ADDENDUM NO. TWO
WARREN WOODS PUBLIC SCHOOLS
TOWER HS-TITAN EXPRESS SERVERY
HAWTHORN FOOD PROGRAM FREEZER REPL.
Page 1 of 1 (write up only)

March 24, 2025

ADDENDUM NO. 02 to the plans and specifications for the WARREN WOODS SCHOOL DISTRICT, TOWER HS – TITAN EXPRESS SERVERY-HAWTHORN FOOD PROGRAM FREEZER REPLACEMENT, Warren, MI, Architect's Project No. 242030, dated March 11, 2025

Cc: Don Ball, Warren Woods Public Schools
Neil Cassabon, Warren Woods Public Schools

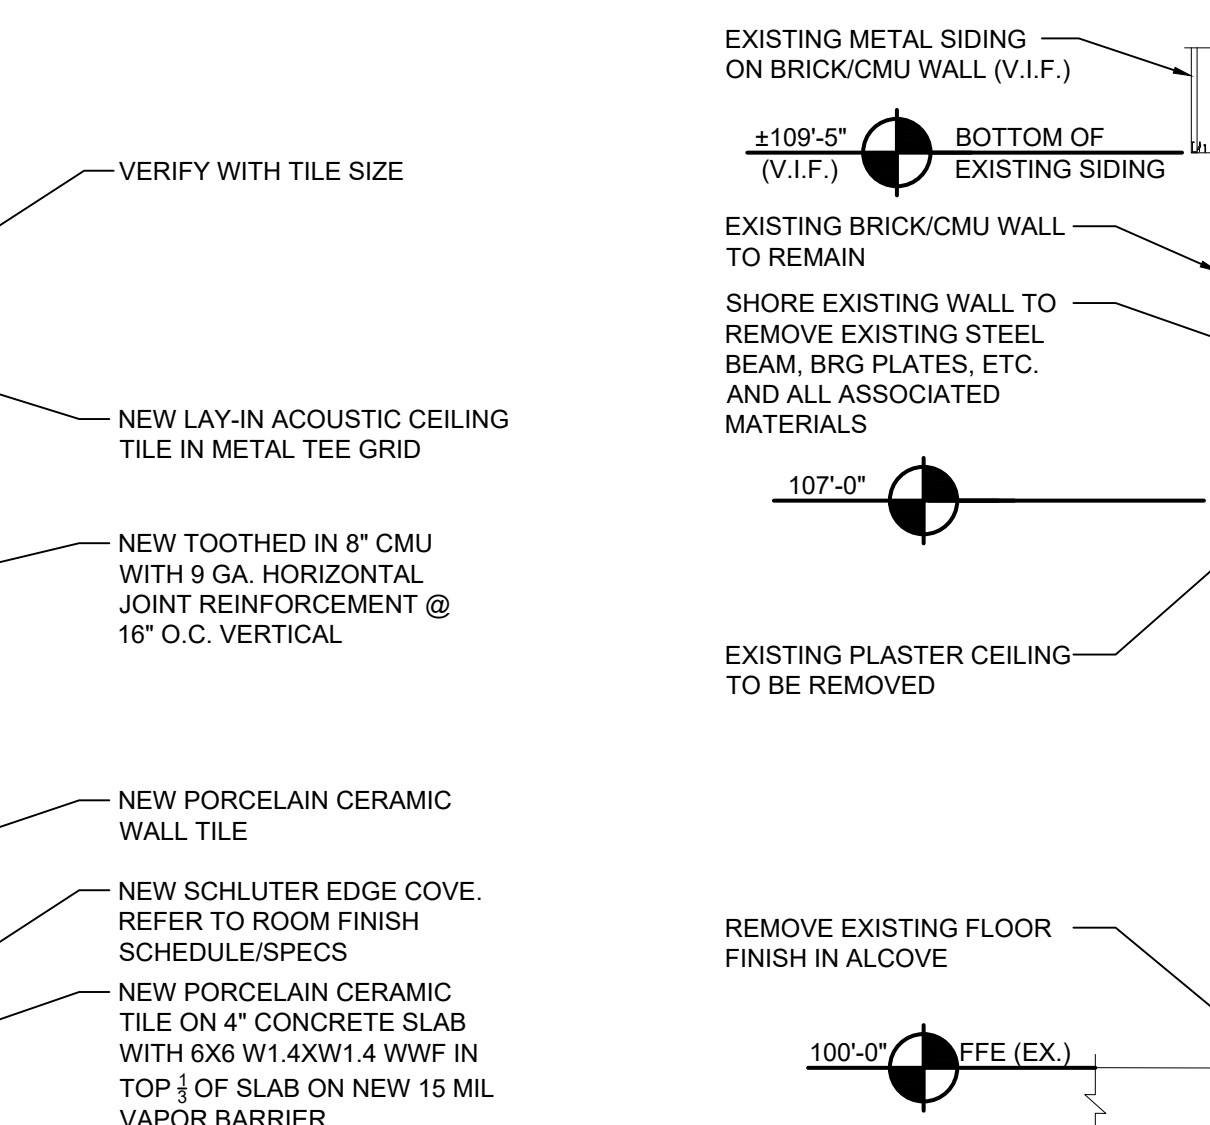
- ITEM NO. A1:** Refer to revised Sheet A6.02 (issued):
1. Added room names on enlarged Plan 2.
 2. Revised Detail 4 indicating to remove and salvage existing brick.
 - a. Clarified room names.
 3. Revised Detail 8 to show new FRP panel and associated backup, revise Spec Section 09772 to match trim and Spec Section 09280, change backup from 1-1/2" rigid furring to 2-1/2" metal studs @ 16" o.c. as shown on revised Detail.
 4. Added Detail 19 showing corner trim at new FRP panel.

SHEET NO.
6.03

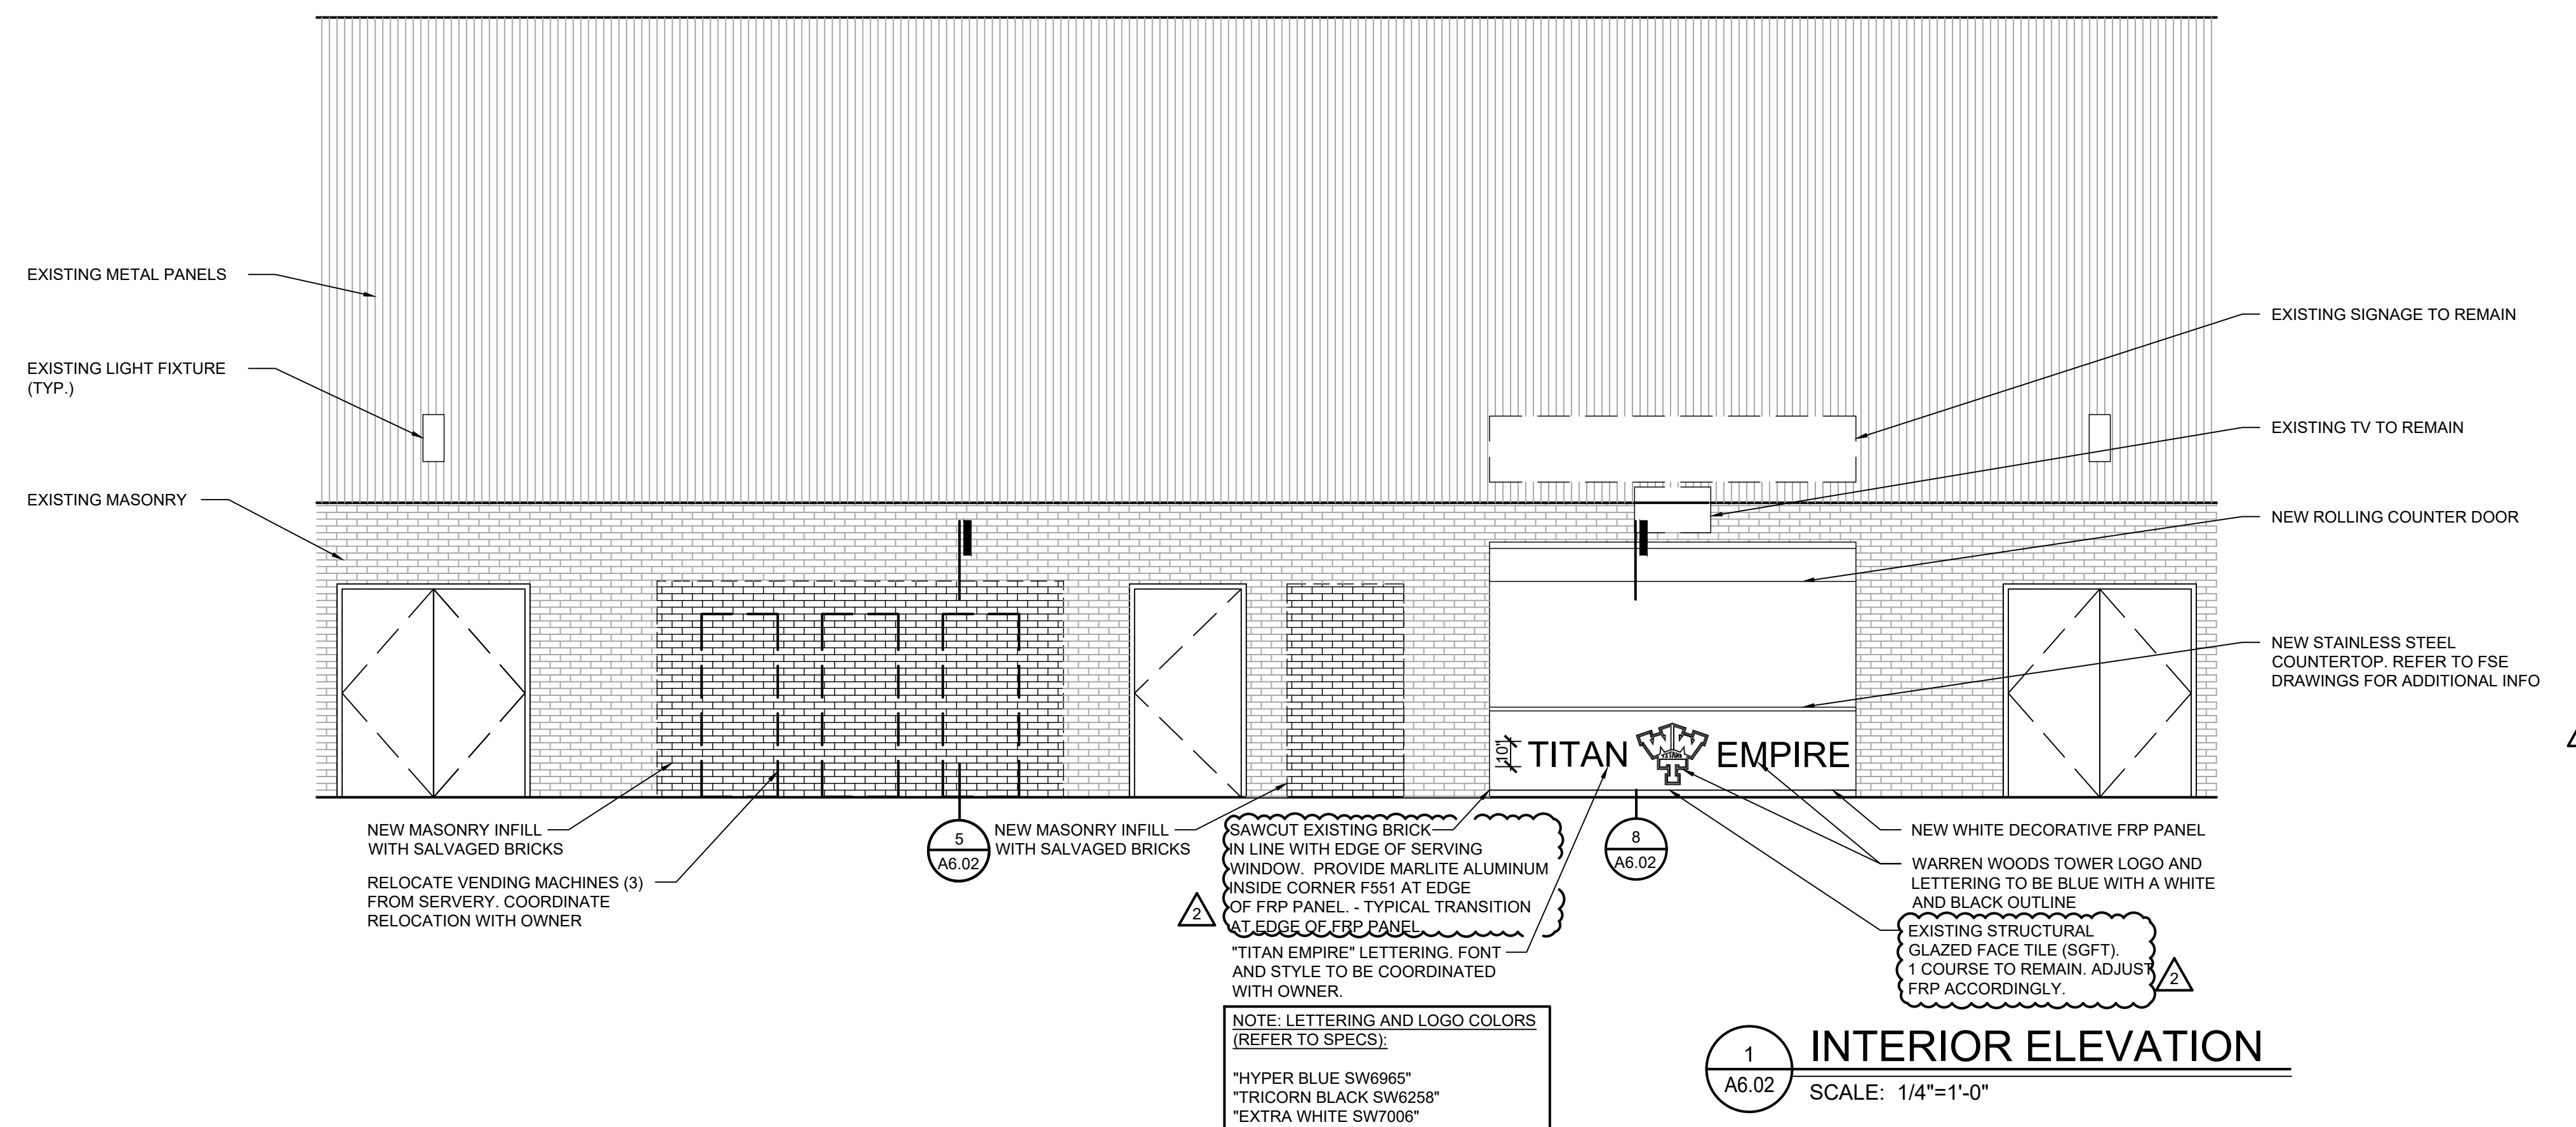
- ITEM NO. A2:** Refer to revised Sheet A6.03 (issued):
1. Modified interior elev. 1 showing new FRP panel.
